**Subject:** FW: 55 Vastern Rd, Reading (200188)

**Subject:** RE: 55 Vastern Rd, Reading (200188)

Figure 14: Configuration 3 - Proposed Development with the Cumulative Surrounding Buildings - Ground and Podium Level, Windiest Season

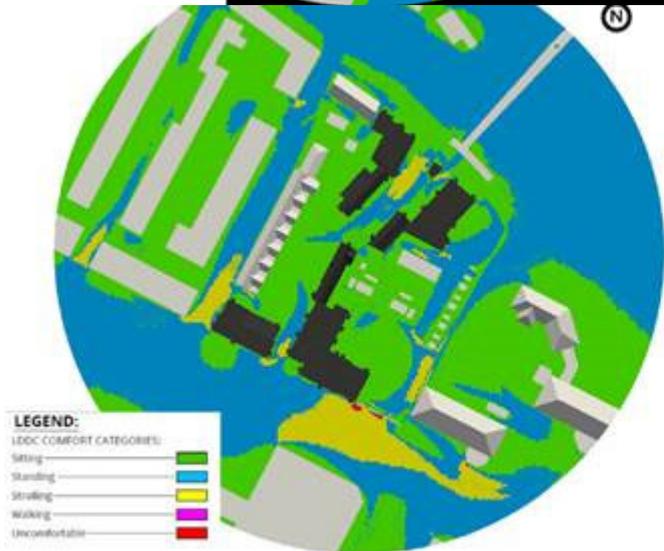
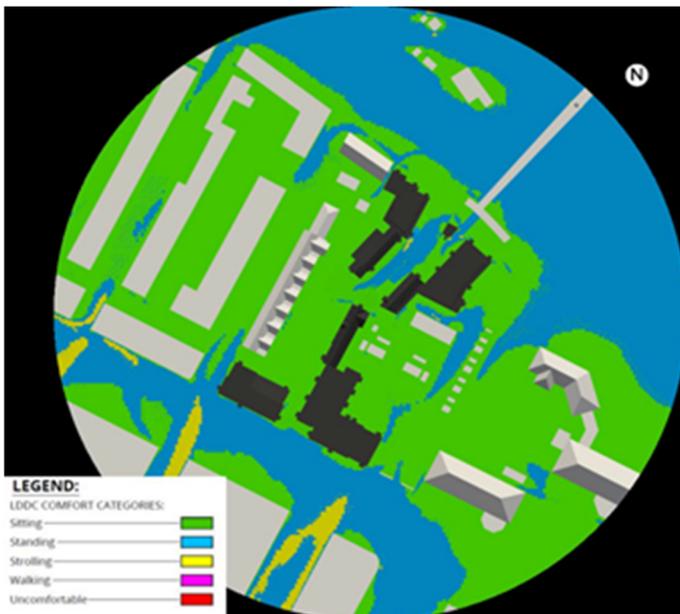
*Issue A) We were unaware that the main doorway is located on the East façade of the Sovereign House south hemi-spherical extension. Given this main doorway location, we agree with the RWDI comments about this doorway, and we also think a comment in their report would be appropriate to clarify this matter. As well as this matter there is a small location to the south of the aforementioned extension which is shown as red (unsuitable for walking and all other more sedentary activities). Our concern is that this location is not suitable for any pedestrian activity and should be mitigated. The discussion of the windy area outside Sovereign House is only relevant to Configuration 3.*

As can be seen from the image above, if the development is as per configuration 4 then there are no wind issues at this location. Furthermore, if Configuration 3 is built first followed by Configuration 4, then the Configuration 3 windy areas (shown above) would only exist temporarily until Configuration 4 is constructed.

We think that this issue should also be commented upon by RWDI in their report and if Configuration 3 will be built then it should be demonstrated that the proposed mitigation measure will ameliorate the windy conditions at the 'red' location near Sovereign House.
